Re: Notice of Intent – Supplement #1  
Rocky Hill MBTA Community at Elm Street  
265, 277, 281, 287, and 287½ Elm Street, Amesbury, Massachusetts  
MassDEP File #002-1362

Re: Peer review response and revised plan submission  
Application: Site Plan Review  
Property: Rocky Hill MBTA Community: Elm Steet

Re: Proposed Rocky Hill MBTA Community Development  
Elm Street, Amesbury, Massachusetts  
**Site Plan and Civil Engineering Peer Review**

**CUT & FILL  
MAIN ROAD  
&  
NORTH**  
FIGURE 1.1

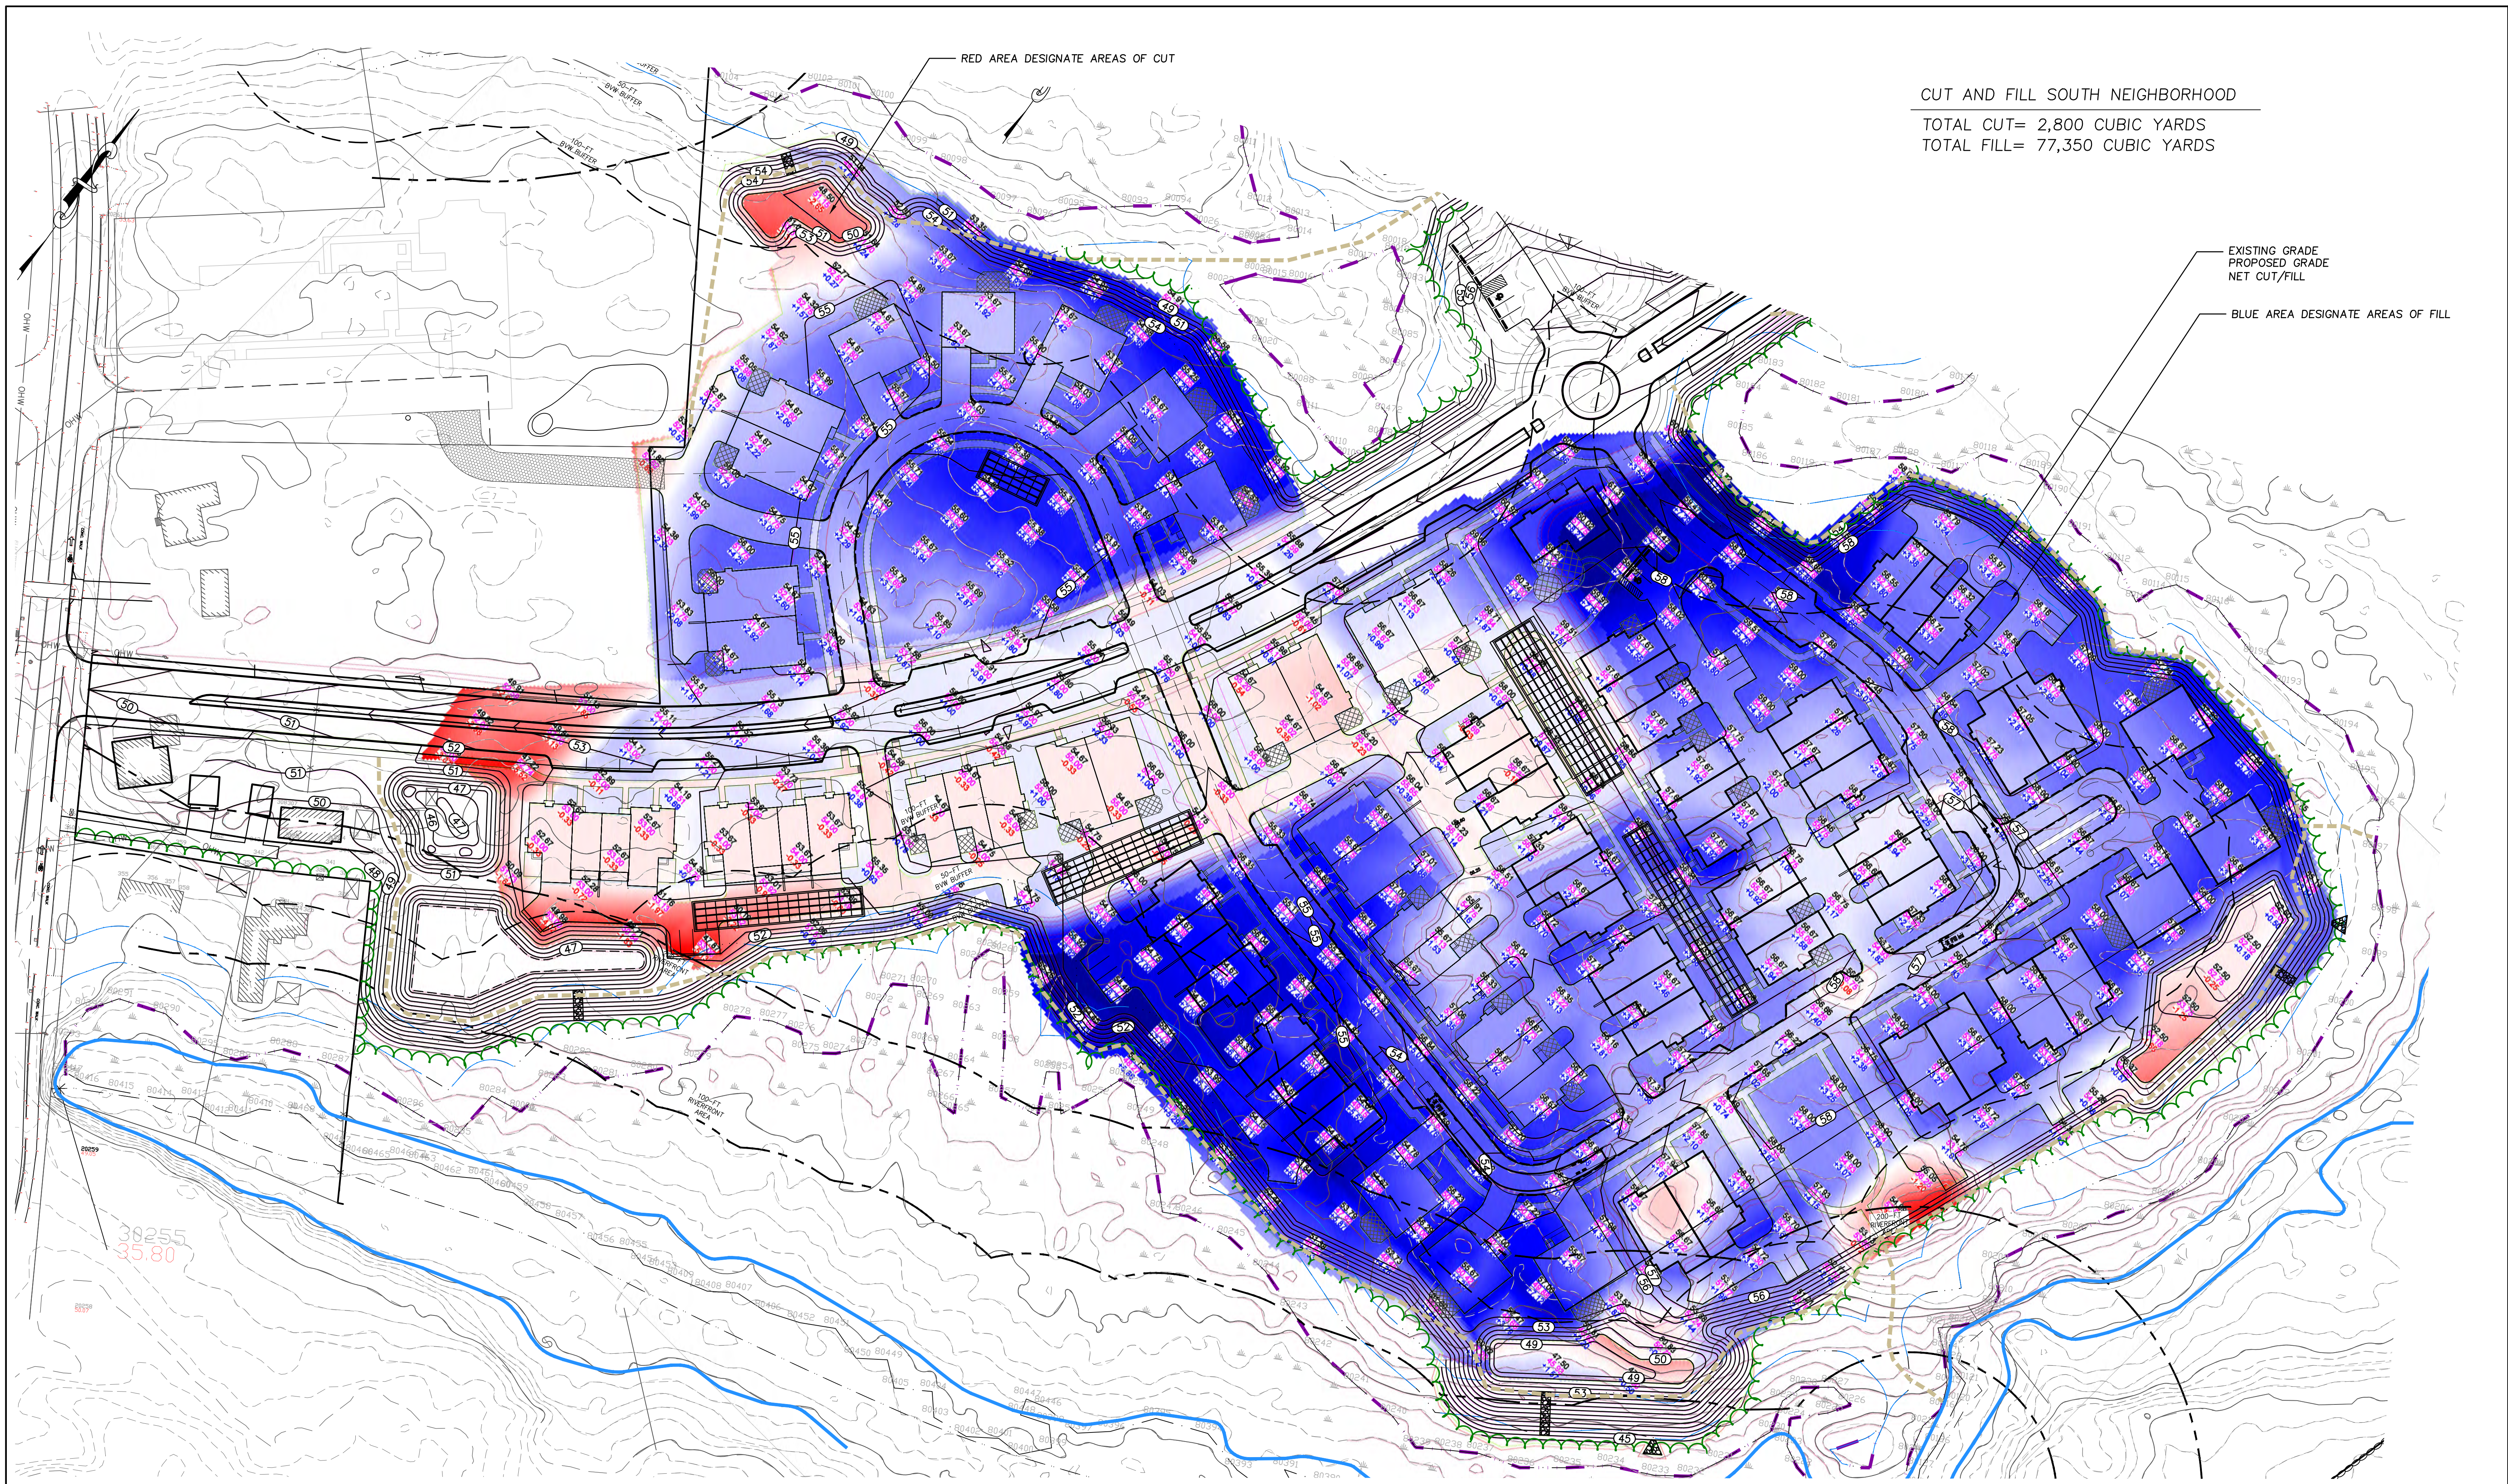
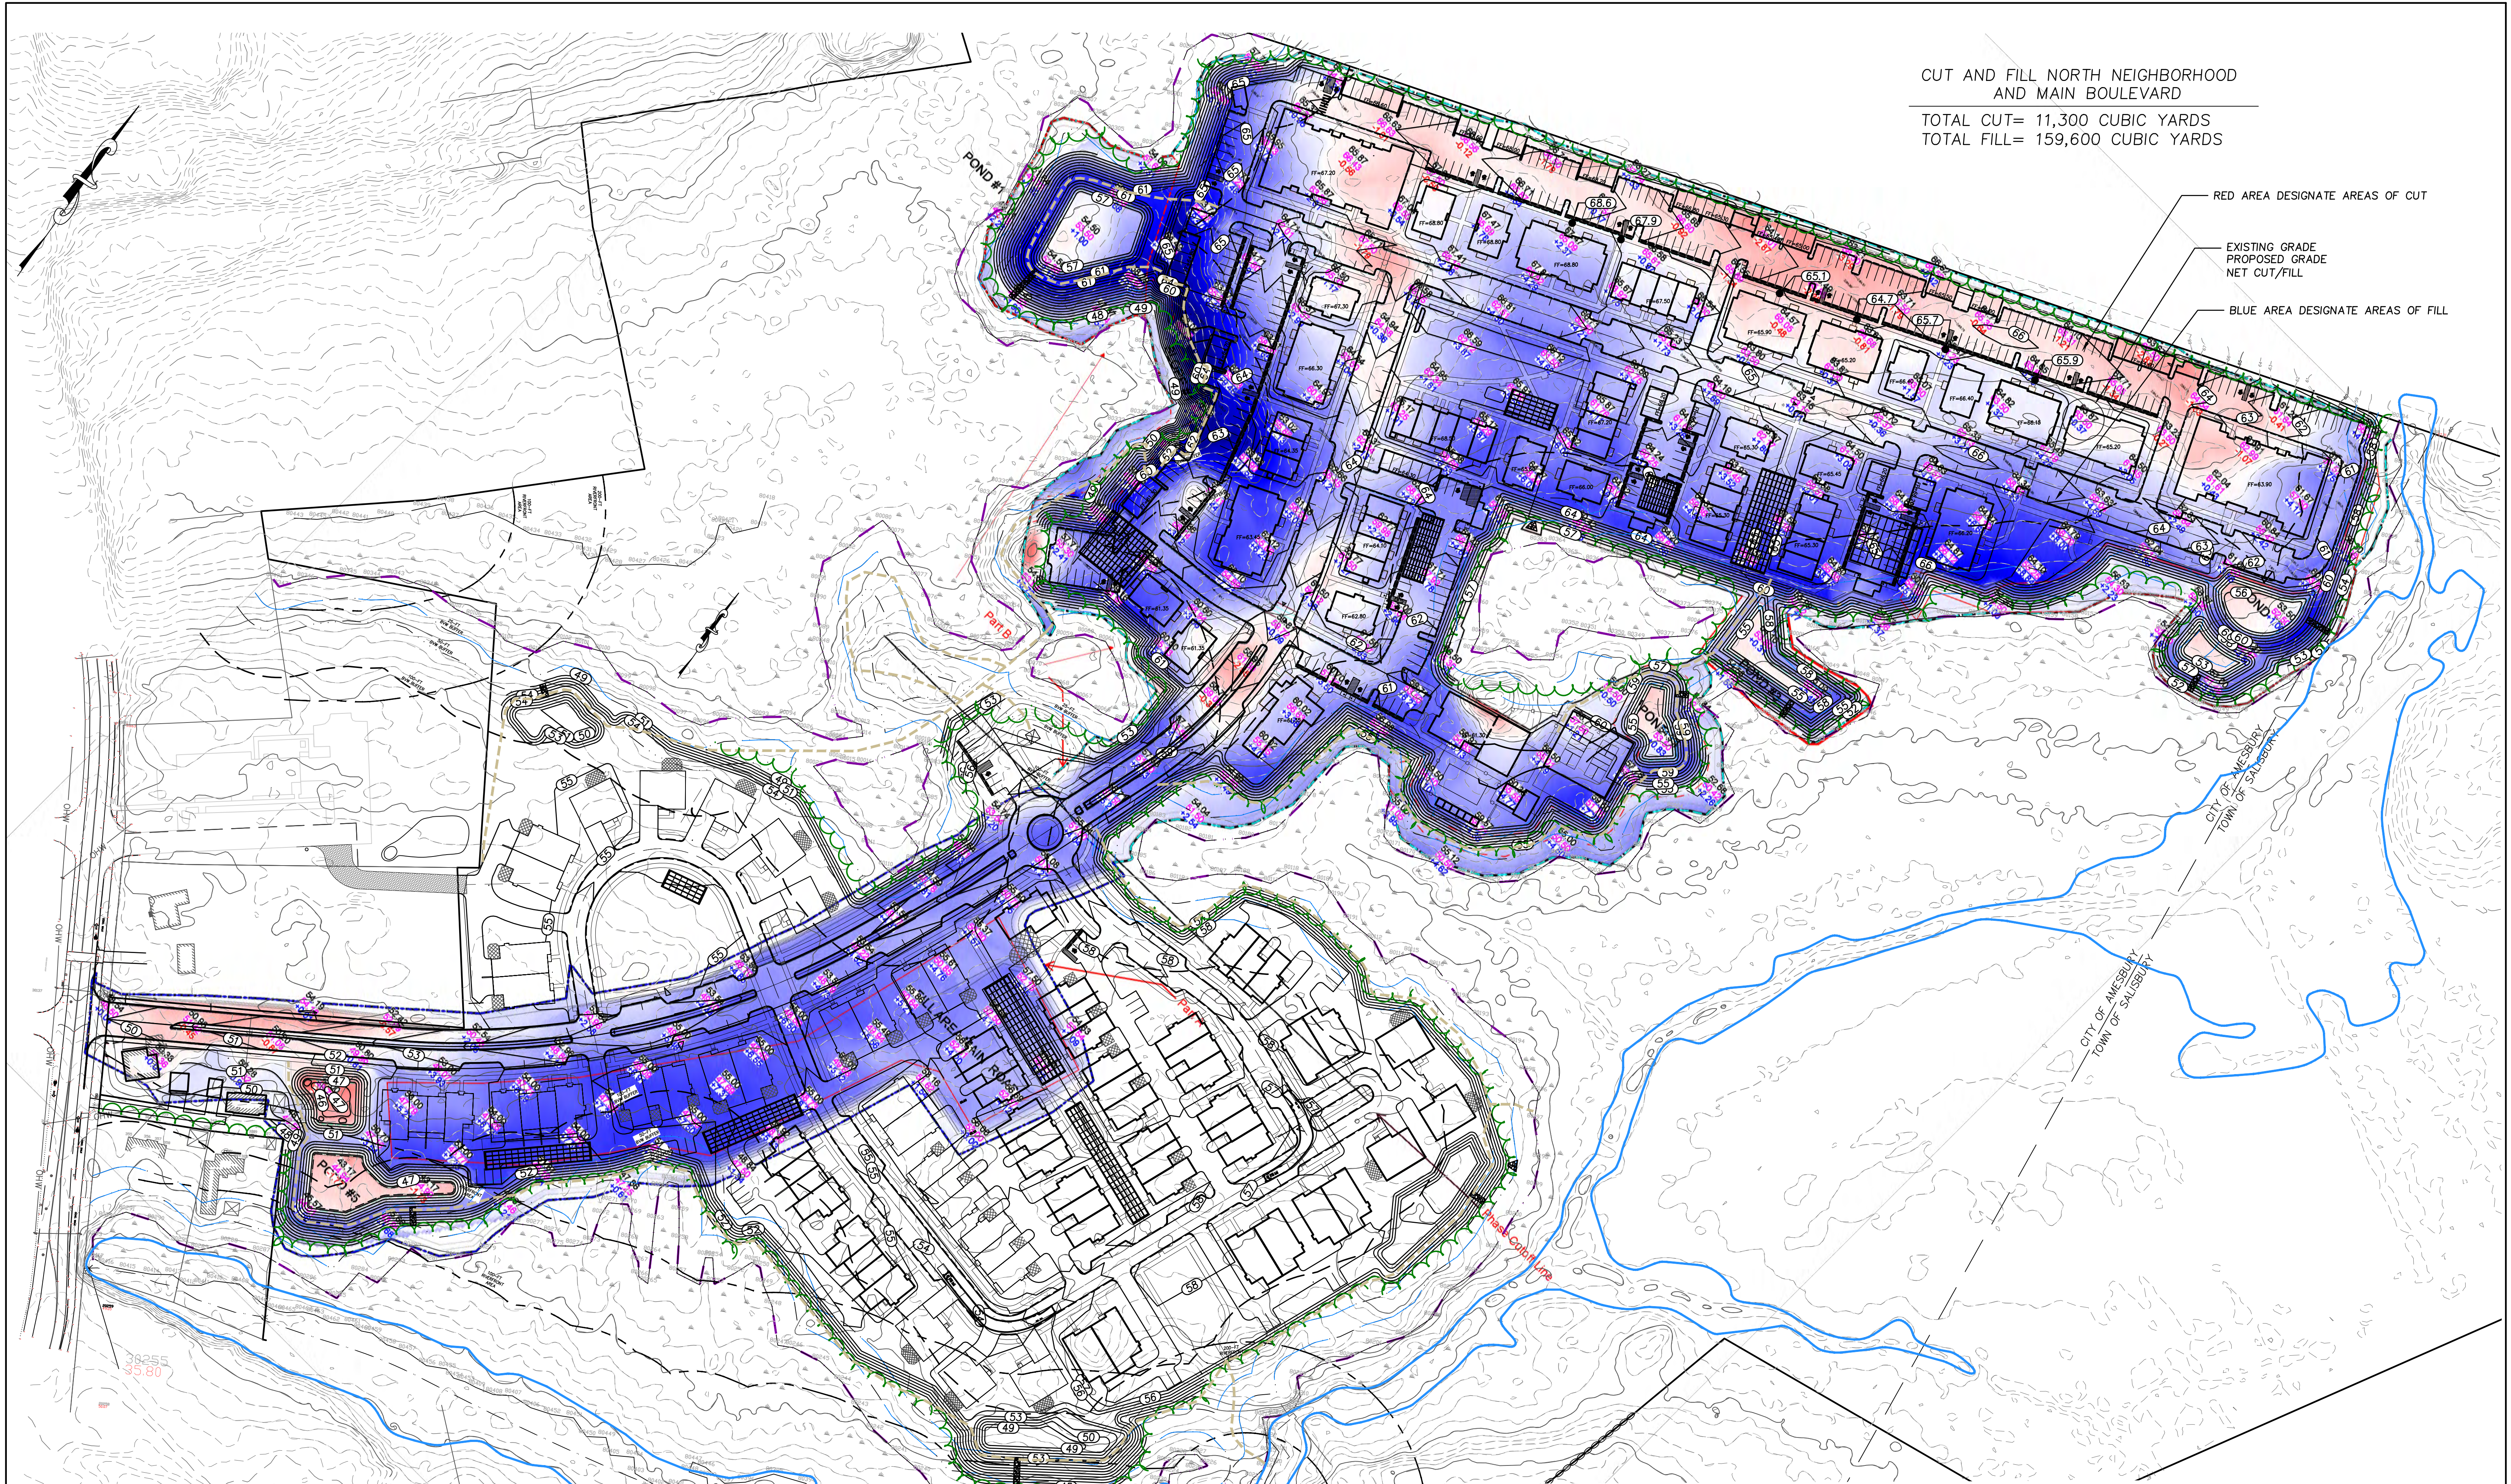
**VHB Comment:** The submitted grading plans depict substantial areas of cut and fill throughout the site; however, the materials do not include a quantitative earthwork summary (cut/fill calculations or balance analysis), nor do they clearly indicate whether material will be exported from or imported to the site. While the project is not before the Board as a Definitive Subdivision, Section XI.Q.10.5.a.5 incorporates applicable Subdivision standards for purposes of Site Plan Review, and earthwork magnitude is relevant to evaluating grading impacts, site stability, and community effects.

In addition, the grading plans do not include representative site cross sections or other graphics that would allow the Board to clearly understand the magnitude of vertical change across the site, particularly in areas of significant fill or cut adjacent to property boundaries or resource areas.

CUT AND FILL NORTH NEIGHBORHOOD  
AND MAIN BOULEVARD  
TOTAL CUT= 11,300 CUBIC YARDS  
TOTAL FILL= 159,600 CUBIC YARDS
